**Field Action Notice for the ASP6025, Leica ASP300 S, Leica ASP200 S,  
HistoCore PEARL, HistoCore Spectra ST**

Leica Biosystems is issuing this Field Action Notice (FAN) to inform you about a Field Action involving the ASP6025, Leica ASP300 S, Leica ASP200 S, HistoCore PEARL and HistoCore Spectra ST. You get this notification as our records indicate that you have received one or more of the instruments concerned and that you have used the Remote Service functionality in the past.

**Label**

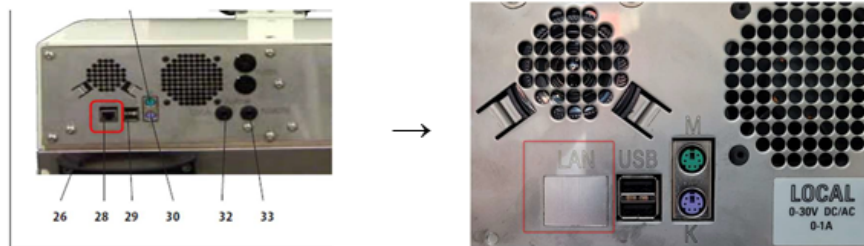
As an immediate action, we ask you to remove the devices from the network by unplugging the network cable and to cover the network port with an enclosed label as shown below, to prevent someone from reconnecting the device to the network.

First clean the surface with alcohol based cleaner around the area where the adhesive label shall be placed (grease free). Then remove the provided enclosed label from the foil and place it on the surface as shown in the pictures below.
